SUZUKI (2-Stroke) Service Bulletin

Subject: RM80 TRANSMISSION
GEAR MODIFICATION

Bulletin No: RM-36
Date: April 29, 1977
Read and Initial
Manager: _____
Parts: _____
Service: AM

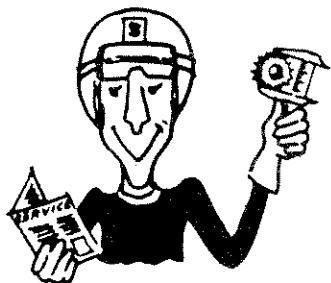
The RM80's first, second, and third transmission gear ratios have been changed to improve low and mid-range engine performance. The changes are as follows:

*If a late style countershaft assembly is used in an RM80 before Frame Number 16025, the late style 2nd and 3rd driven gears must also be installed.

If an early style countershaft assembly is used in an RM80 on or after Frame Number 16025, the early style 2nd and 3rd driven gears must also be installed.

Subject: RM MODEL CYLINDER PORT
CHAMFER RECOMMENDATIONS

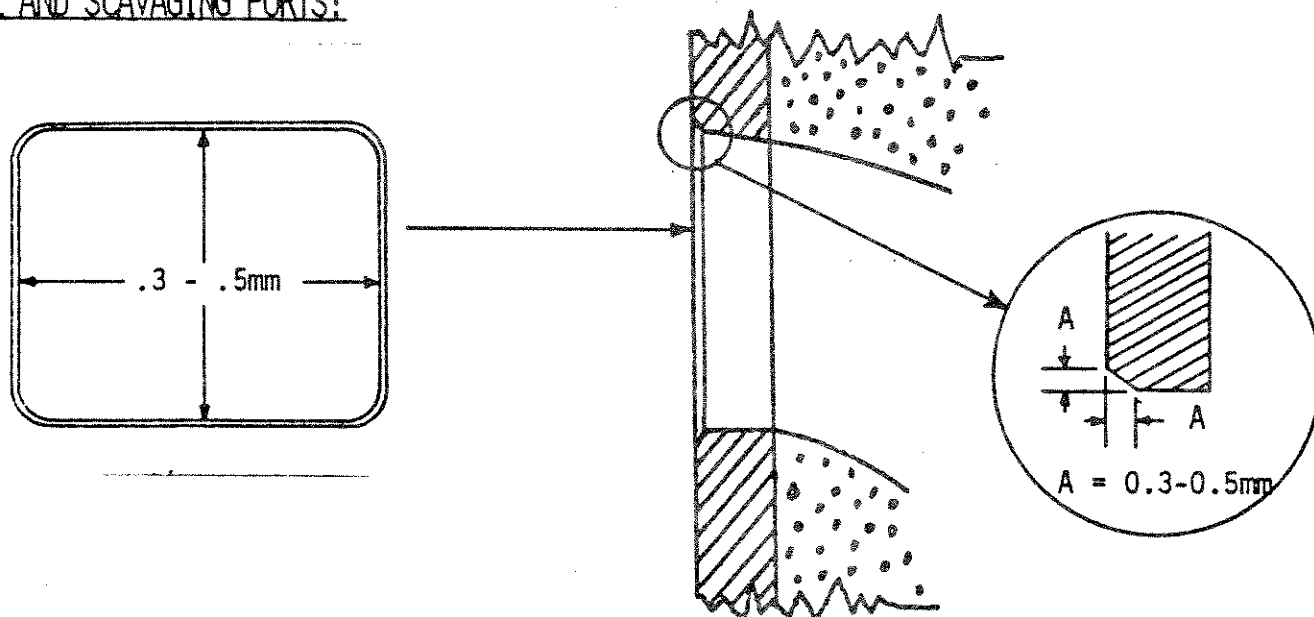
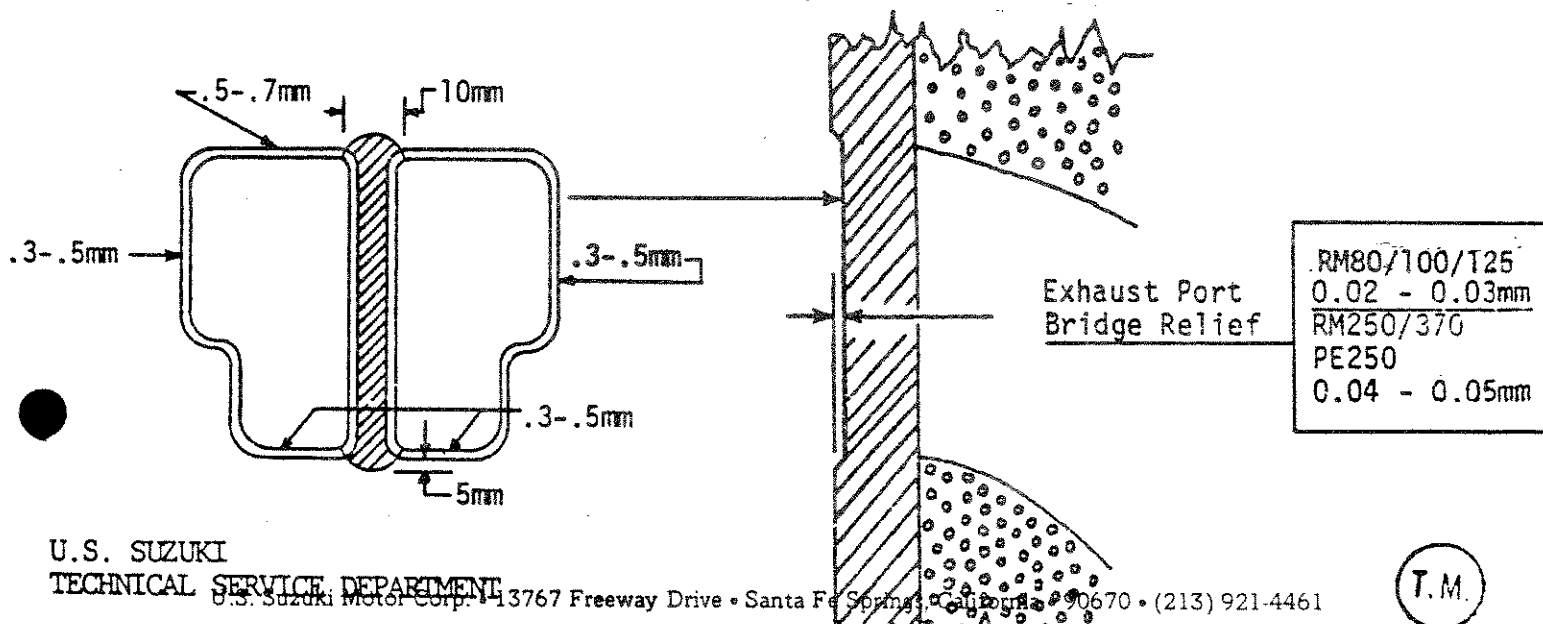
Cylinder port chamfer is very important, with regard to extended piston ring life. The lack of proper chamfer around a cylinder port can cause the piston rings to snag in the ports, which will cause ring breakage and/or excessive piston ring groove and cylinder wear.

Too much port chamfer can cause an abnormal amount of piston ring noise. For these reasons, it is important to chamfer cylinder ports after reboring any RM cylinder. Listed below are chamfer specifications for all RM models.

1. Original Style Chain Tensioner

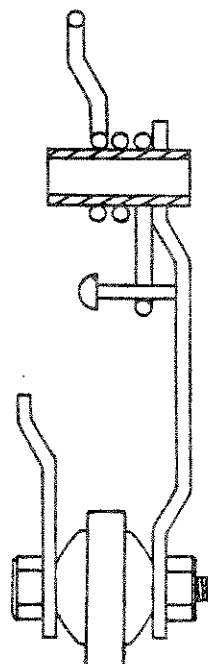
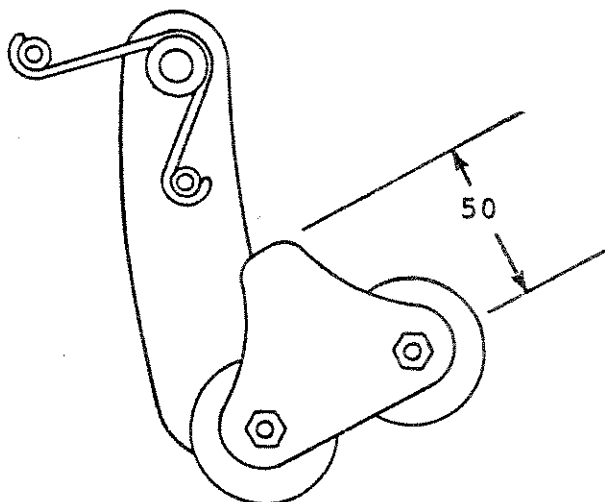
RM125's from Frame Number 43983 (beginning of "B" model production) to Frame Number 51727, have the original style chain tensioner installed.

2. Second Style Tensioner

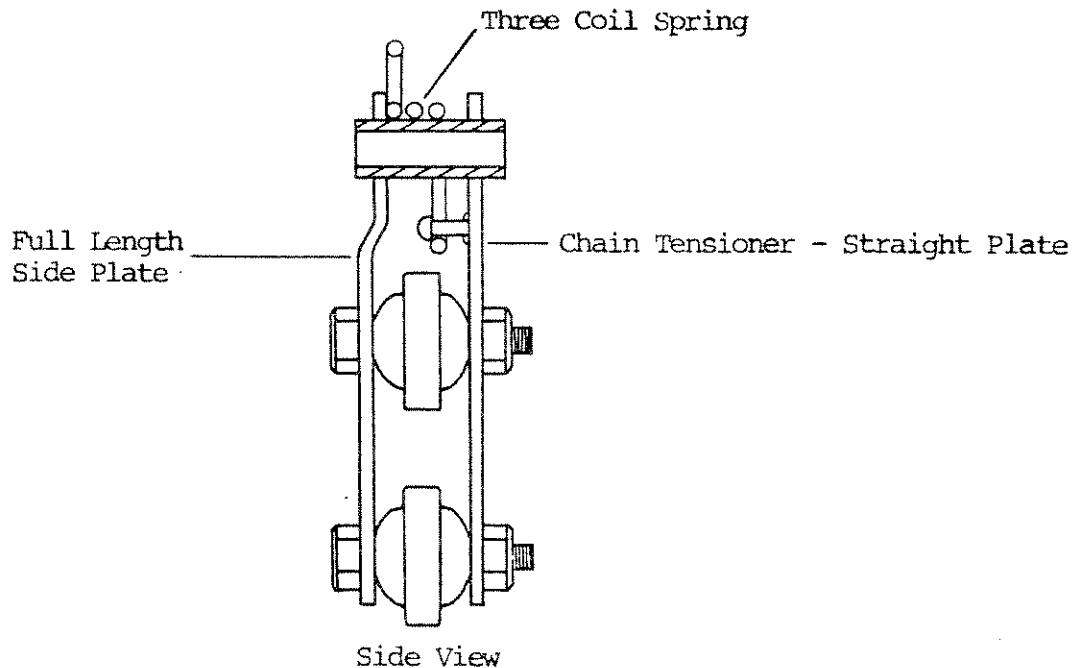
- a. The side plate was changed from 50mm in length to a full length plate.
- b. The chain tensioner's shape has been changed to a straight plate as illustrated above.

RM125's having a Frame Number 51728 through 52687 have the second style components installed.

3. Third Style Tensioner

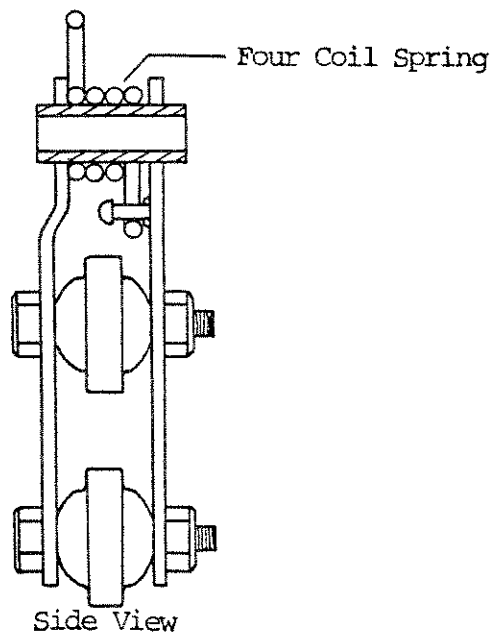
- a. The chain tensioner's spring was changed from a three coil style to a four coil style which increases spring tension. The remainder of the tensioner components remain the same.

The third style chain tensioner has been installed on RM125's on and after Frame Number 52688.

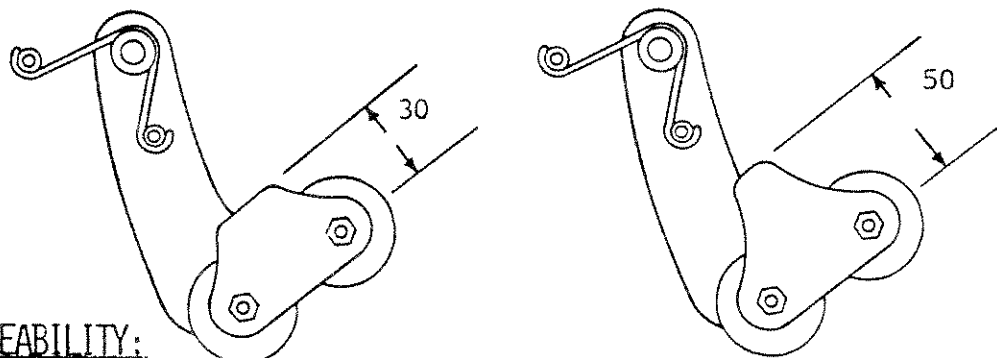
1. The RM80's chain tensioner has been modified by changing the original side plate as illustrated below.

TRANSMISSION DRAIN PLUG

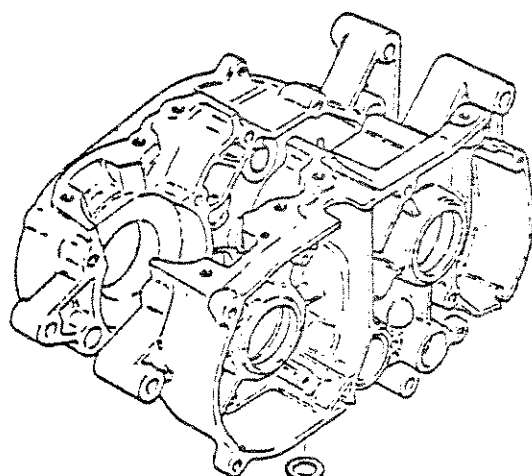
The diameter of the transmission drain plug and crankcase hole on the RM80 have been reduced from 14 mm to 10 mm.

To avoid damaging the crankcase, tighten new and old drain plugs to the following torque specifications:

DRAIN PLUG	TIGHTENING TORQUE
New 10 mm	180-280 kg-cm
Old 14 mm	250-400 kg-cm
